CWSP SYSTEM HARDENING FIELD SCOPING DOCUMENT

PM: 35217268	Project Name: SH - BUCKS CREEK 1101 CB	
Notification: 120047659	Region: Northern	City: Rock Creek
Project Manager: [REDACTED]	Division: North Valley	County: Plumas

B) Fire History – WIFire Map at <https://firemap.sdsc.edu/> to produce the fire history image.

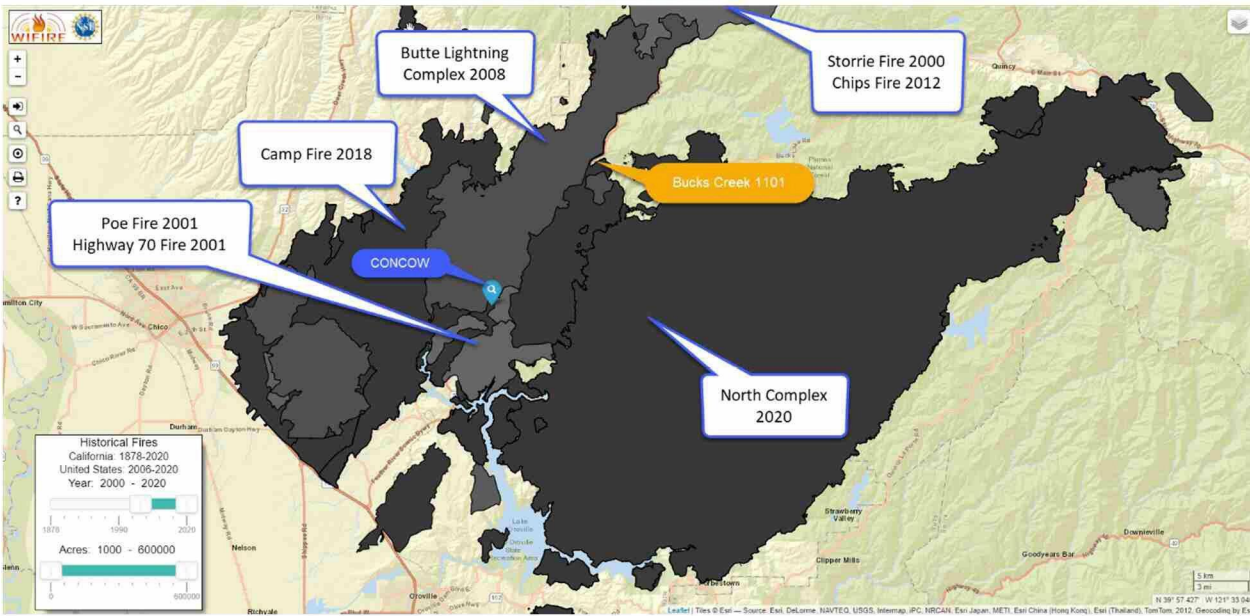
- This area has significant fire history directly impacting the project area. A 20 year look back at area fire history includes, the 56,000 acre Storrie fire (2000), 8,000 acre Poe fire (2001), 1700 acre Highway 70 fire (2001), 50,000 acre Butte Lightning Complex (2008), Canyon Complex (2008), 30,000 acre Chips Fire (2012), 154,000 acre Camp fire (2018) and the 320,000 acre North Complex 2020 all burned within the Feather River Canyon.

- Not all the fires were directly in the project footprint area; however, they show that this area is prone to significant, large fire history due in large part to steep, rugged, inaccessible terrain and periods of strong wind.

- The Feather River drainage is prone to daily diurnal winds and strong north/Diablo wind events at various times of the year, but most notably during the fall period when fuels are at their driest. These conditions have resulted in the area being affected routinely by PSPS events and has also resulted in many large, devastating fires originating in the Feather River drainage.
